SHOPS AT MCLAUGHLIN II

DEVELOPMENT PLAN

FILE # PCD FILE NO. PPR-17-055

Markup Summary

1 SITE PLAN
DP 1 1" = 20'-0"

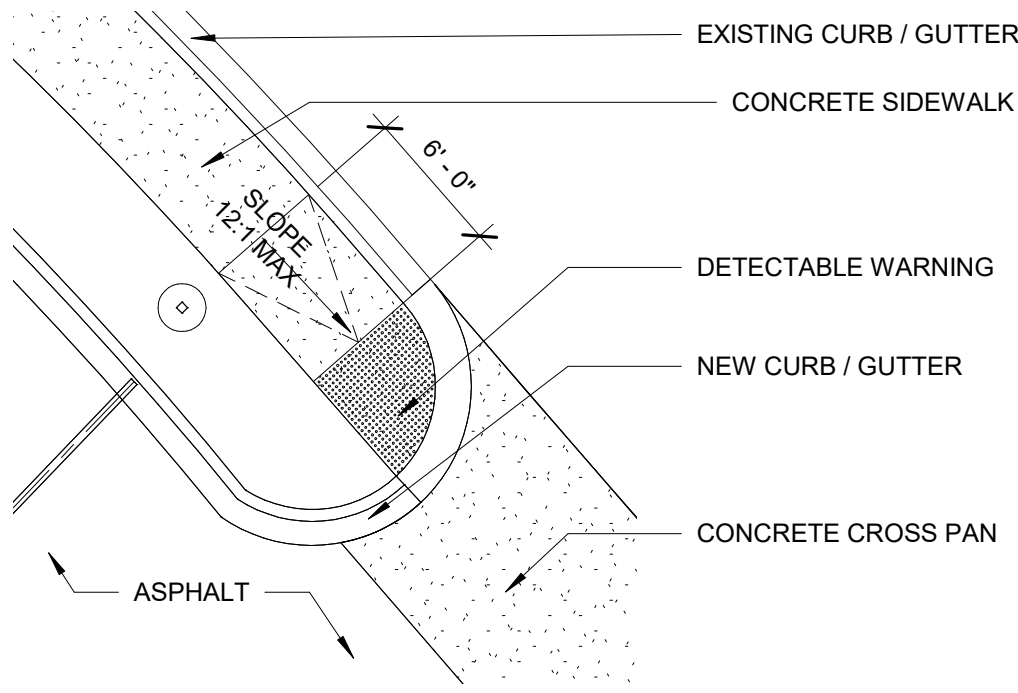
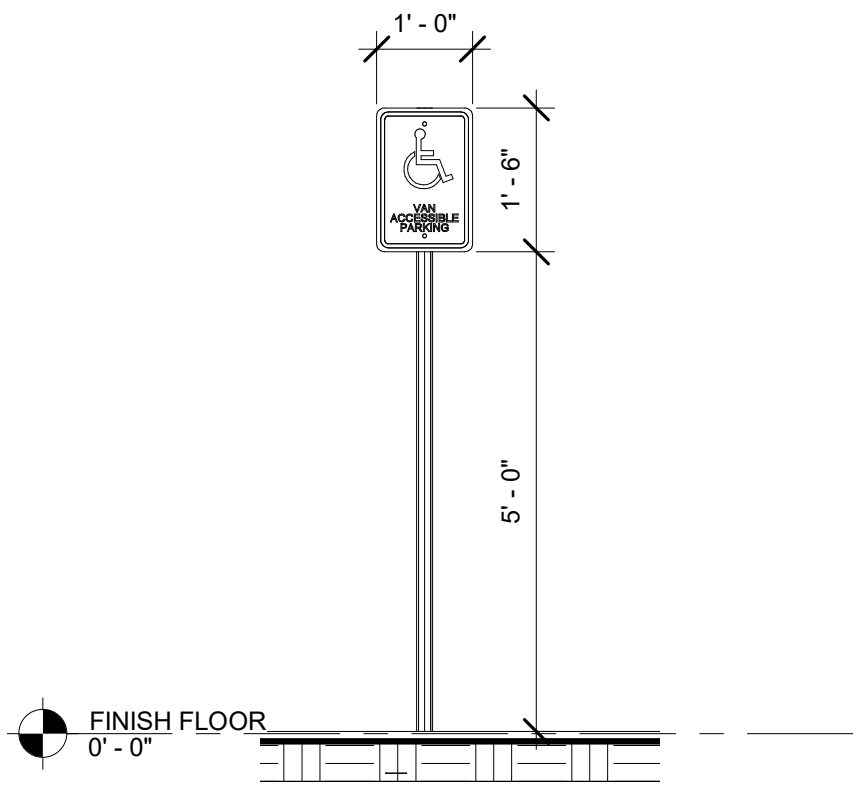
Neither the Plat or Lot 5 site plan identify a cross access drive. A cross access agreement and offsite improvement with the adjacent owner must be obtained. Provide a copy to the County.

8 SITE-CURB/GUTTER @ SIDEWALK
DP 2 1" = 1'-0"

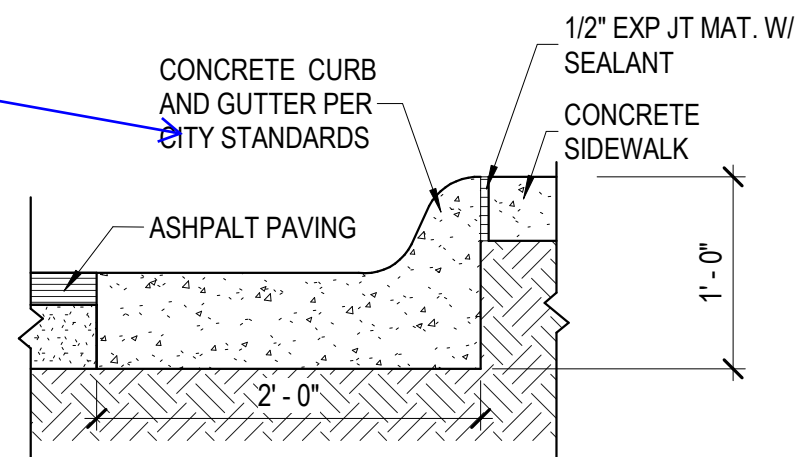
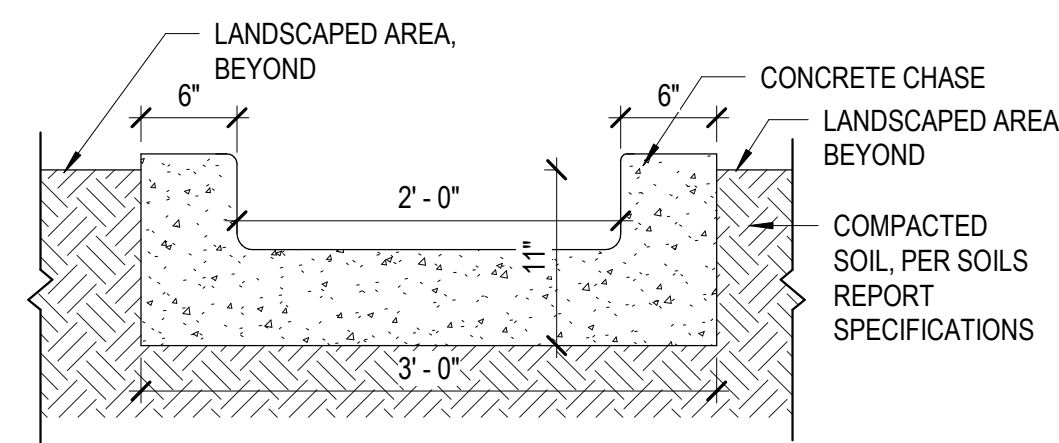
County Standards.
Identify the specific
C&G type. See detail
SD_2-20

County Standards.
Identify the specific C&G type. See detail SD_2-20

DATE	2/22/18
CHECKED	LD
DRAWN BY	JF
PRELIMINARY UTILITIES AND PUBLIC FACILITIES PLAN	
C1

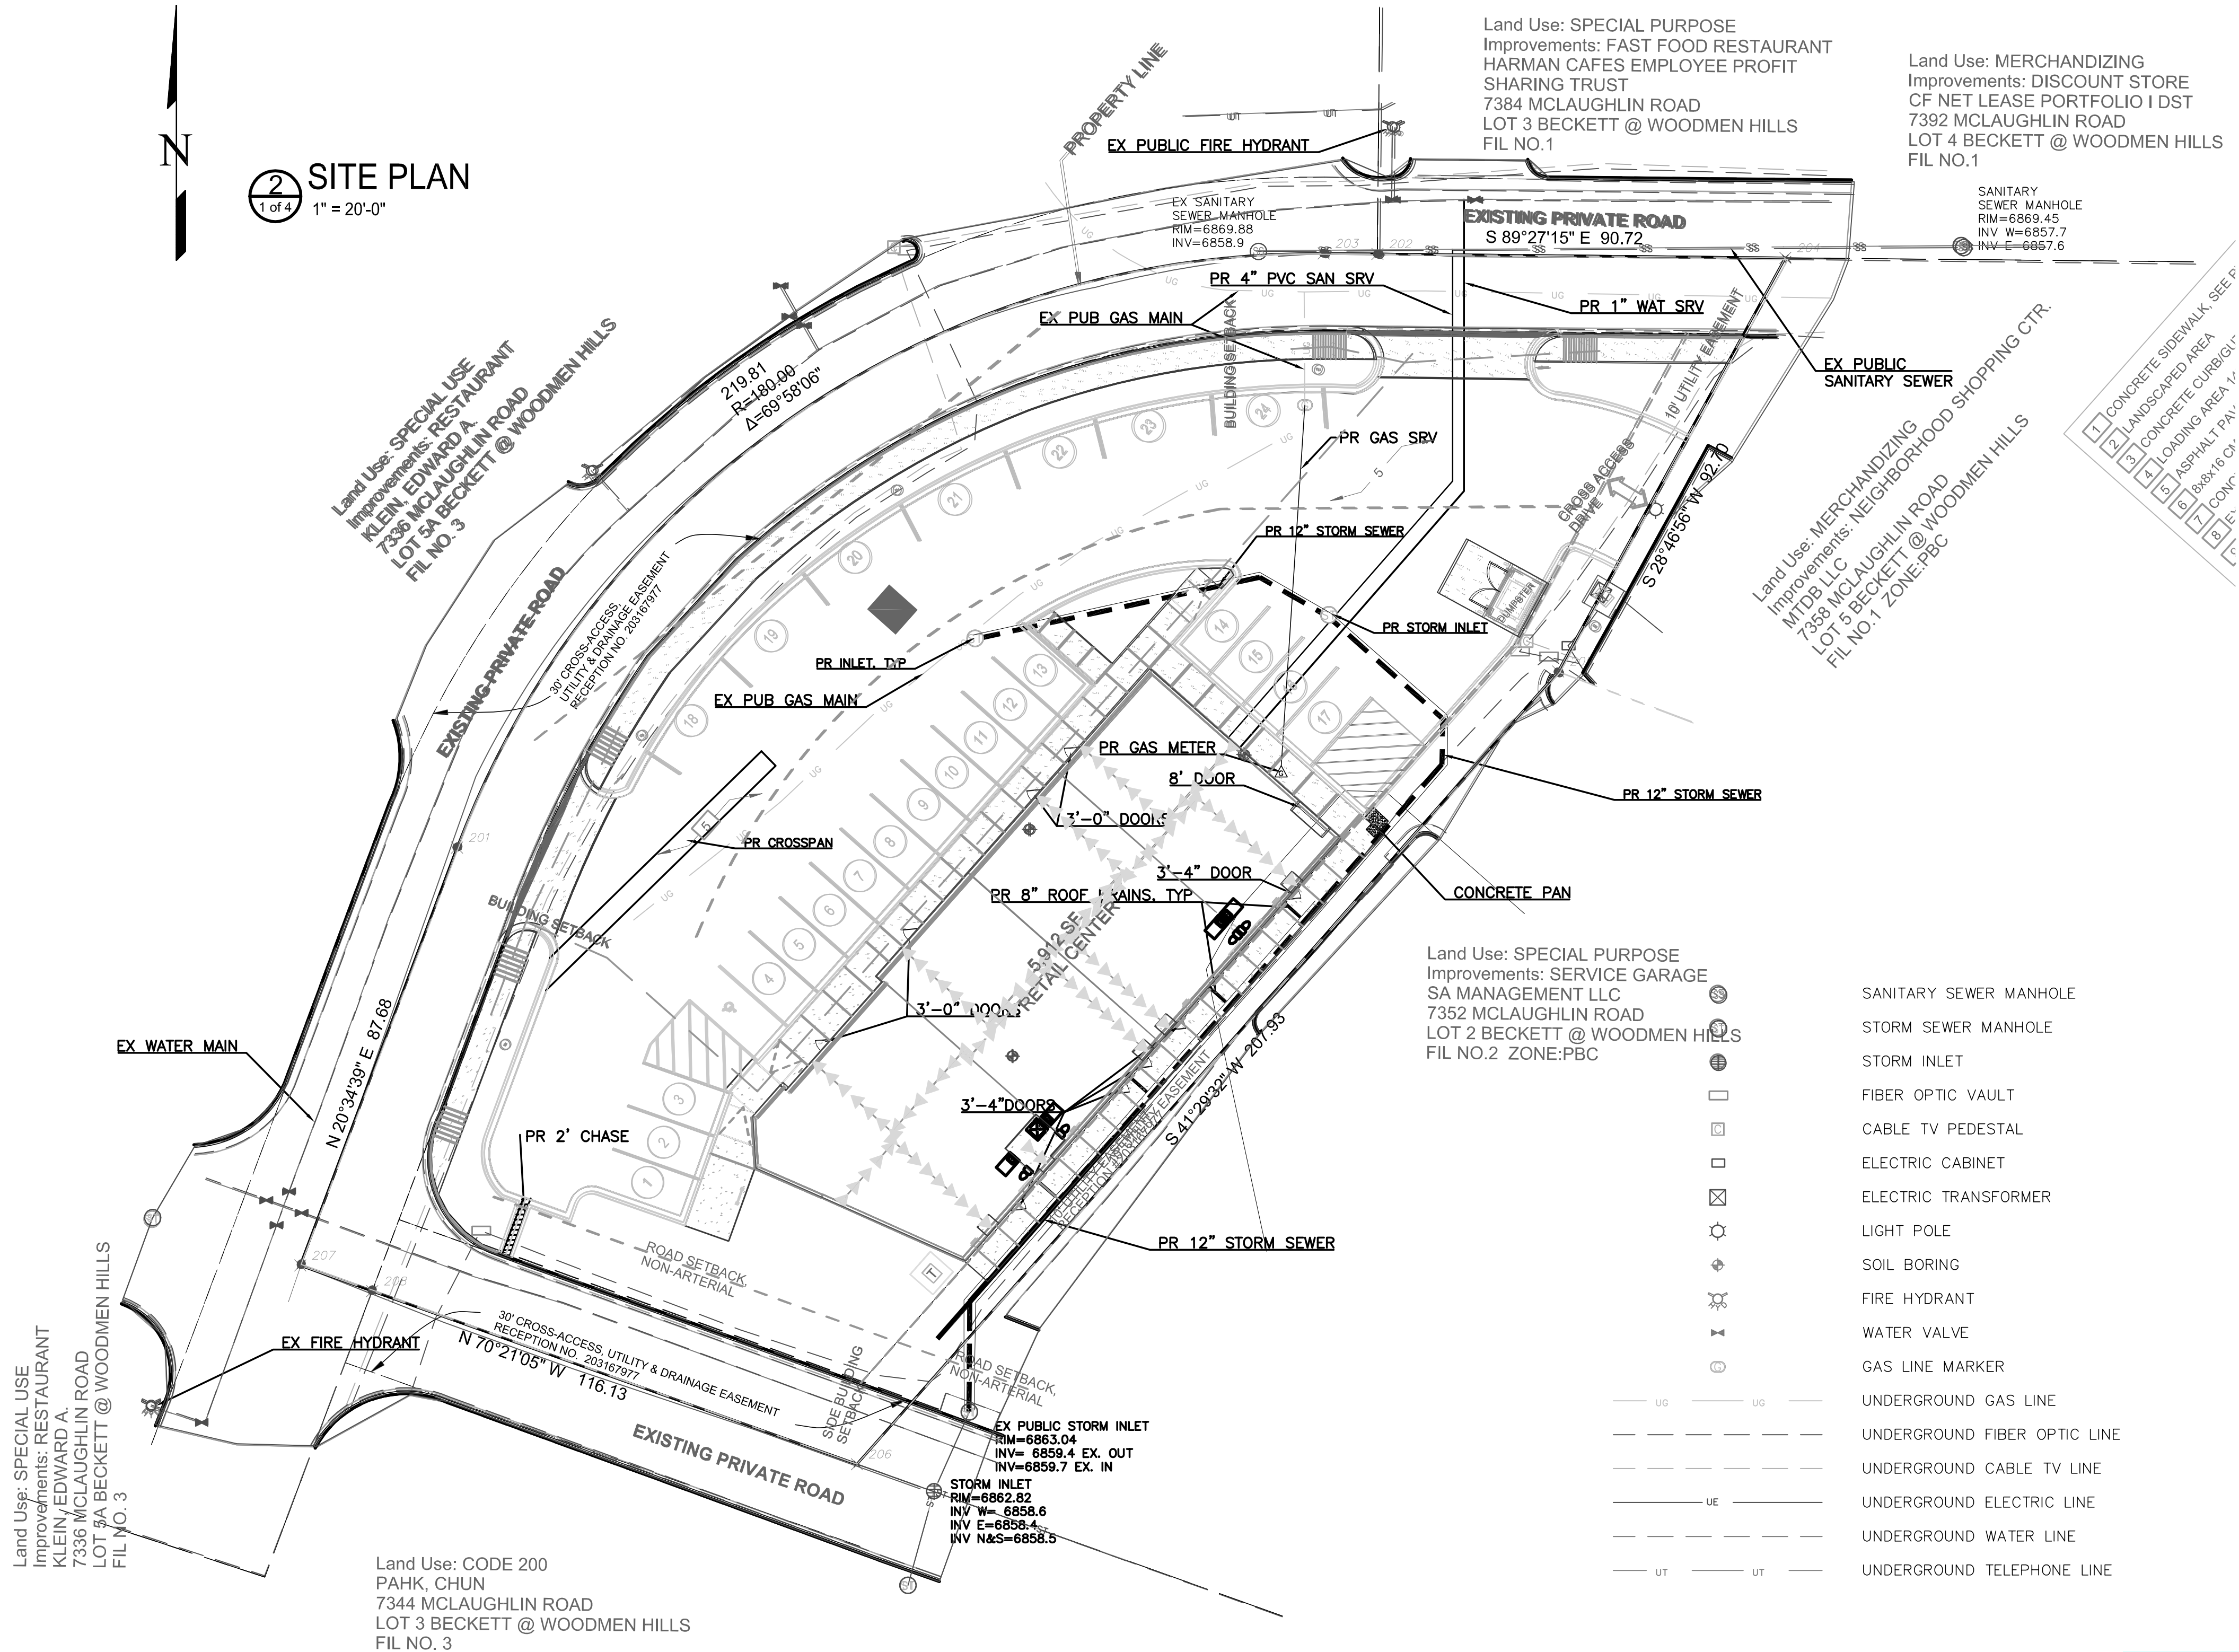
Remove the word
Preliminary

Remove the word Preliminary

PROPOSED
DRAINAGE
MAP

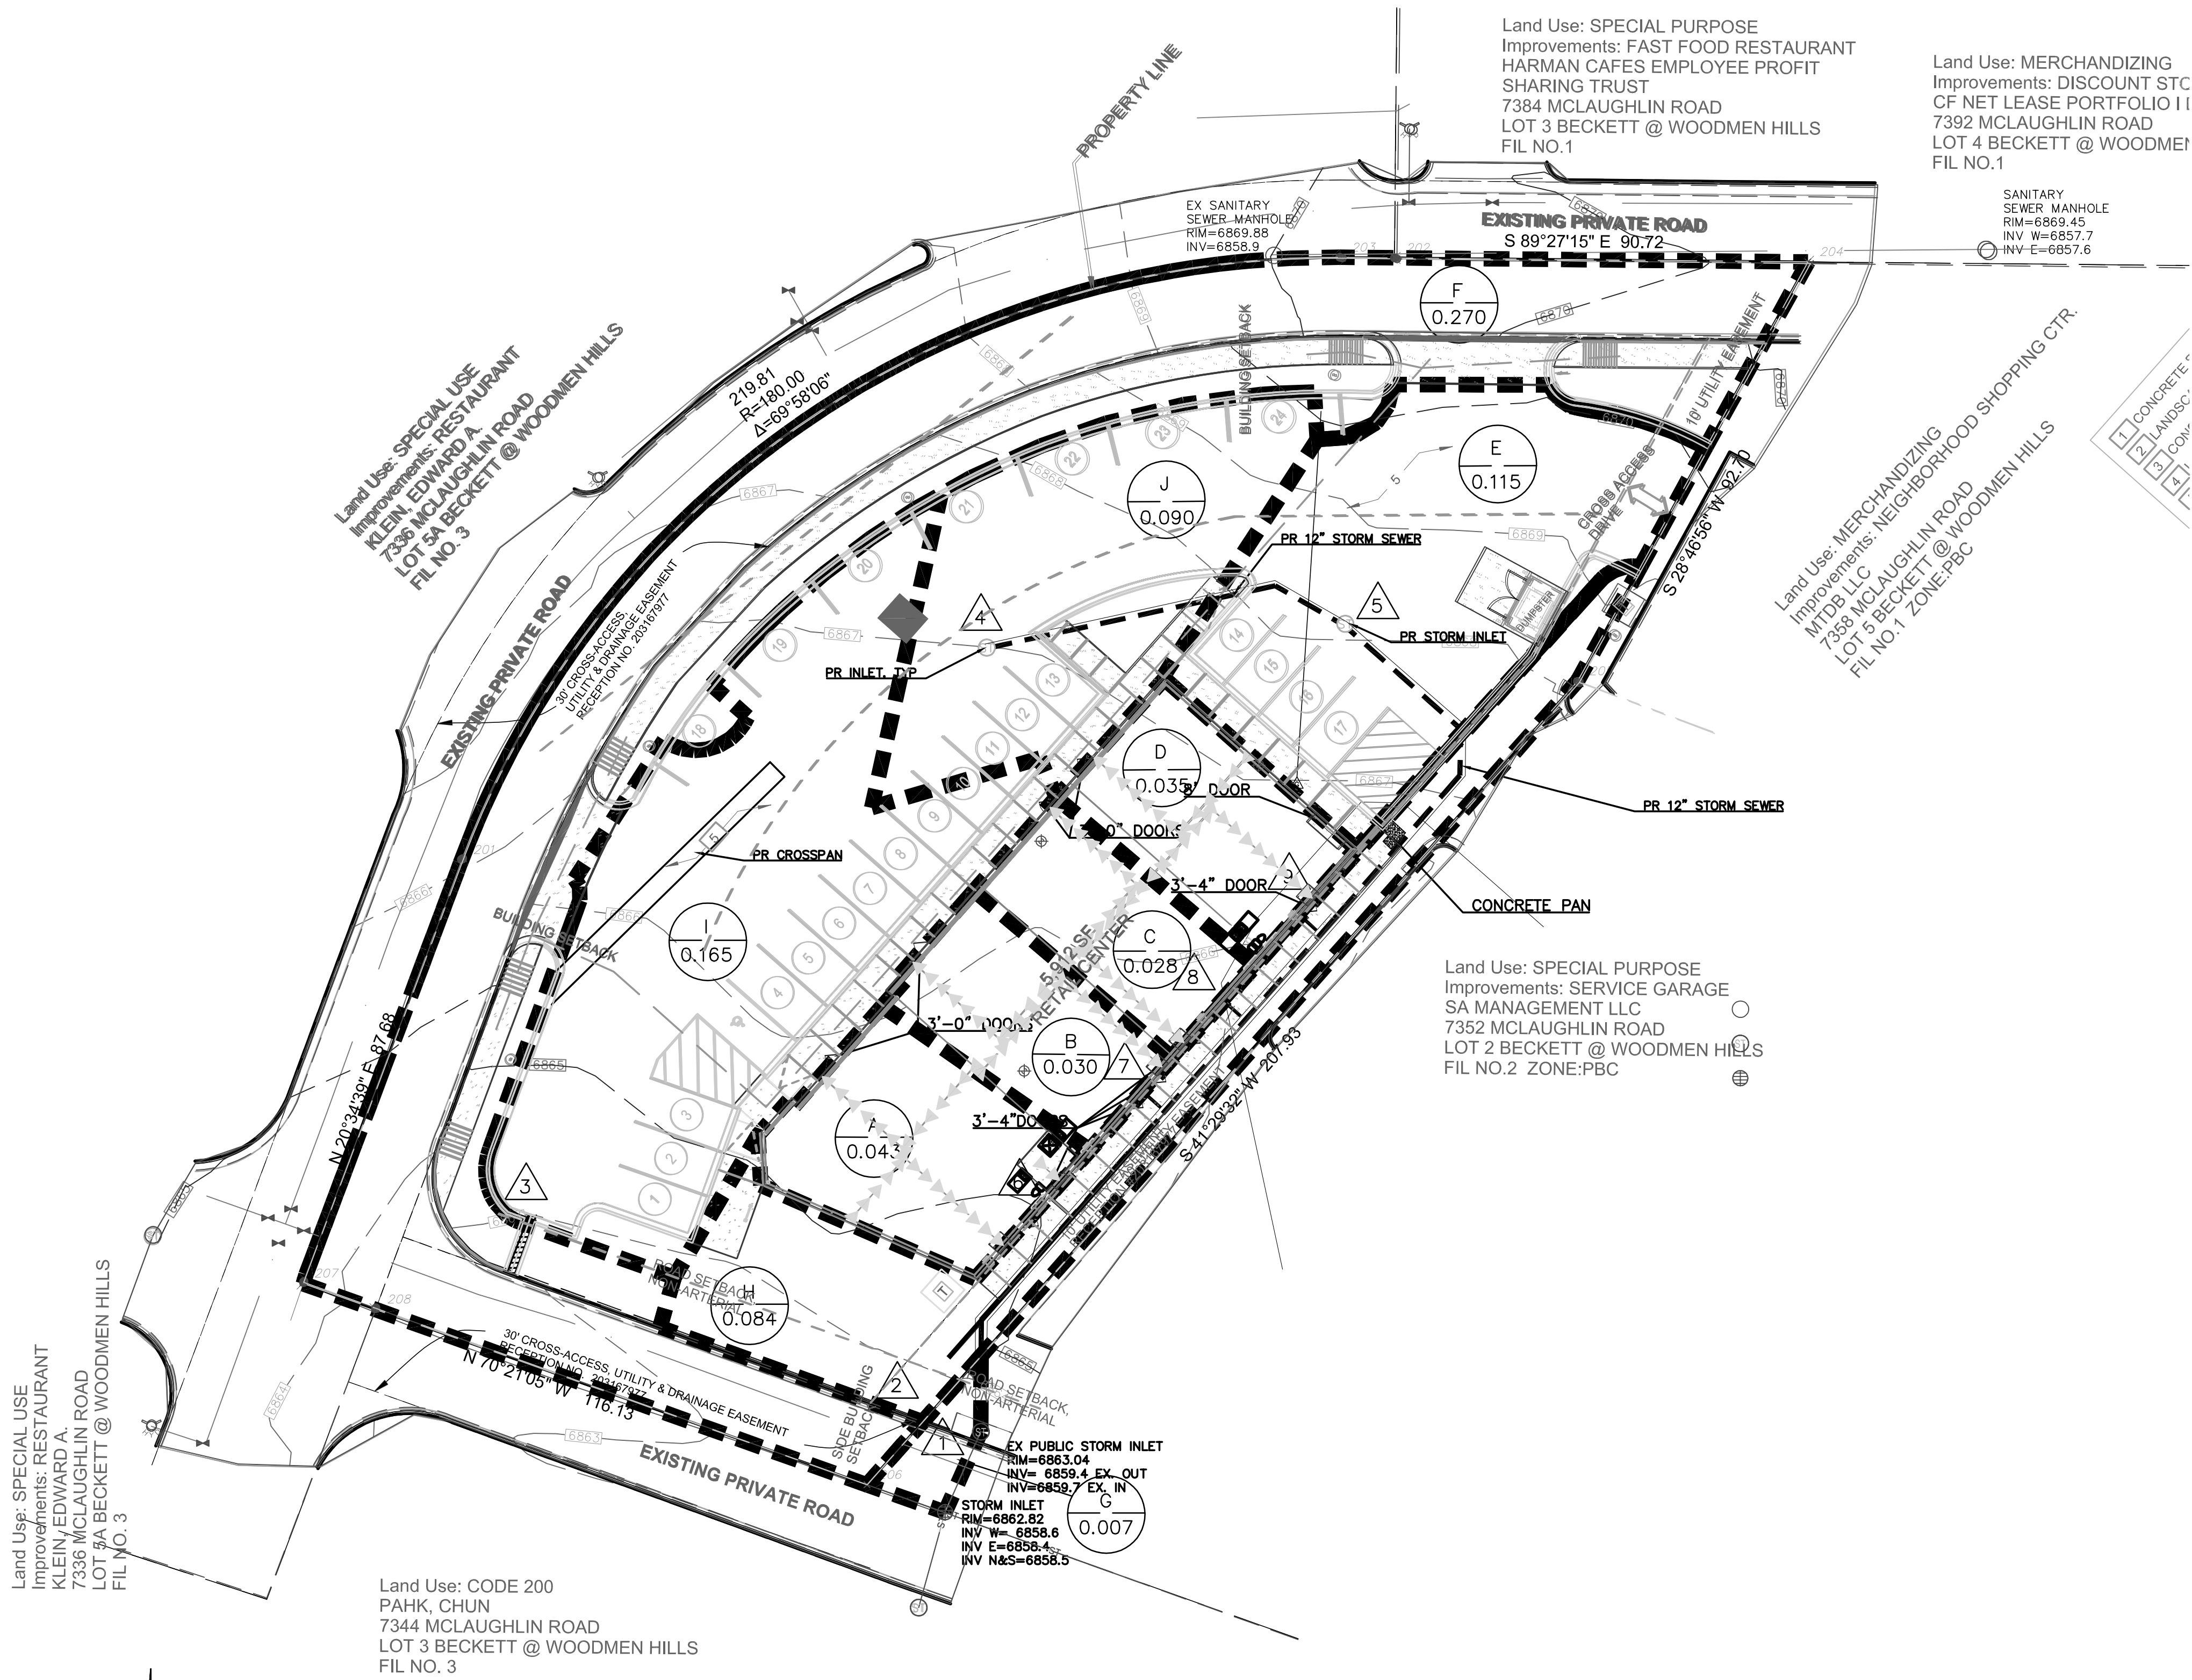
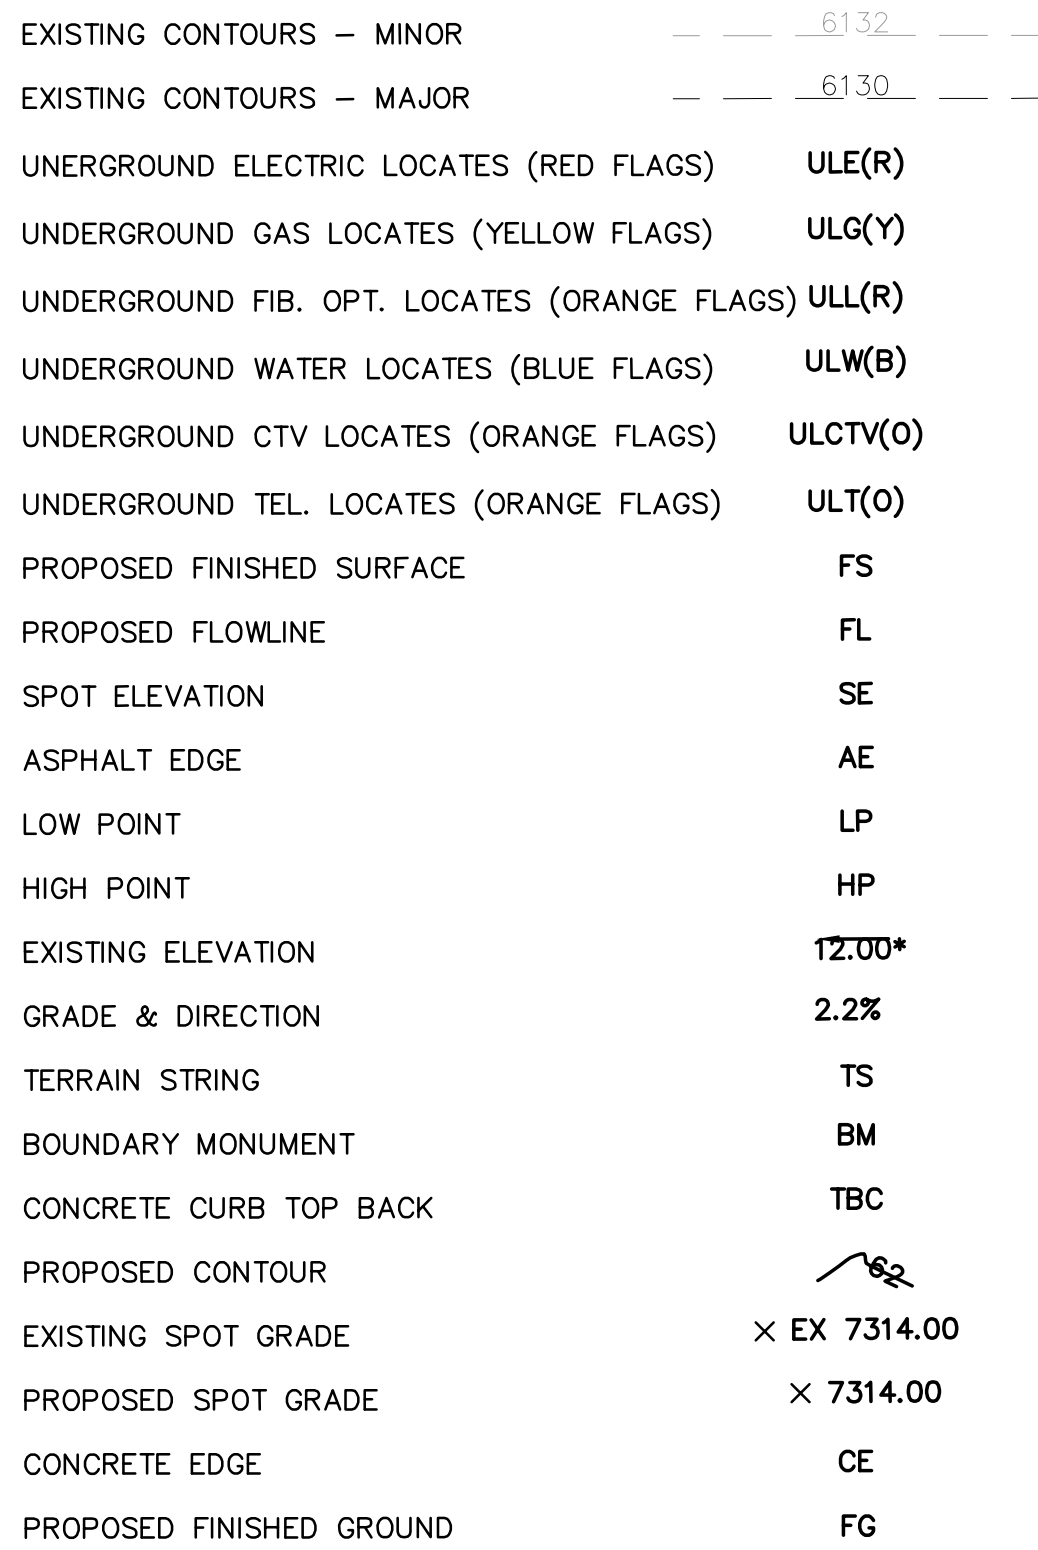
Remove the proposed drainage map from the site development plan set and include the drainage map in the drainage report.
